AMENDMENT NO. 3 MAY 1976
TO
IS : 6297 (Part I)-1971 SPECIFICATION FOR
TRANSFORMERS AND INDUCTORS (POWER,
AUDIO, PULSE AND SWITCHING) FOR
ELECTRONIC EQUIPMENT

PART I GENERAL REQUIREMENTS AND TESTS

(This supersedes Amendment No. 2)

FIG. 2 ARRANGEMENT FOR CENTRE TAP BALANCE TEST

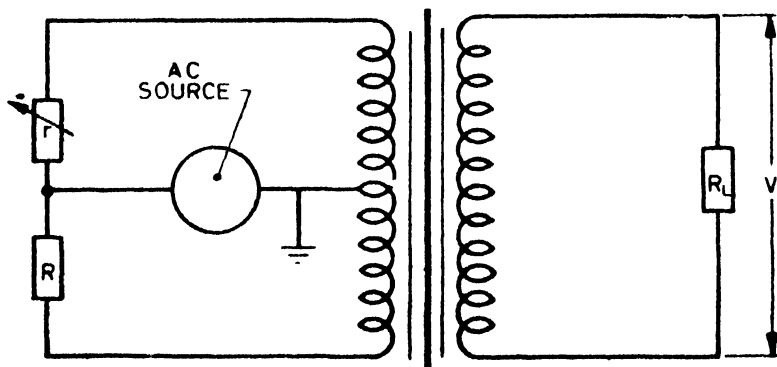
(Page 12, clause 6.2.3.2) — Add the following new clause after 6.2.3.2 and re-number the subsequent clauses and figures accordingly wherever they appear:

6.2.3.3 Centre tap balance test (for centre tapped winding) — The balance of centre tapped winding shall be checked by connecting the transformer as shown in Fig. 2.

The resistor r shall be adjusted until voltage V across the load R_L goes through minimum. The limits shall be as specified when calculated from the formula:

$$\text{Change of voltage in } dB = 20 \log_{10} \frac{R}{r - R} \quad)$$
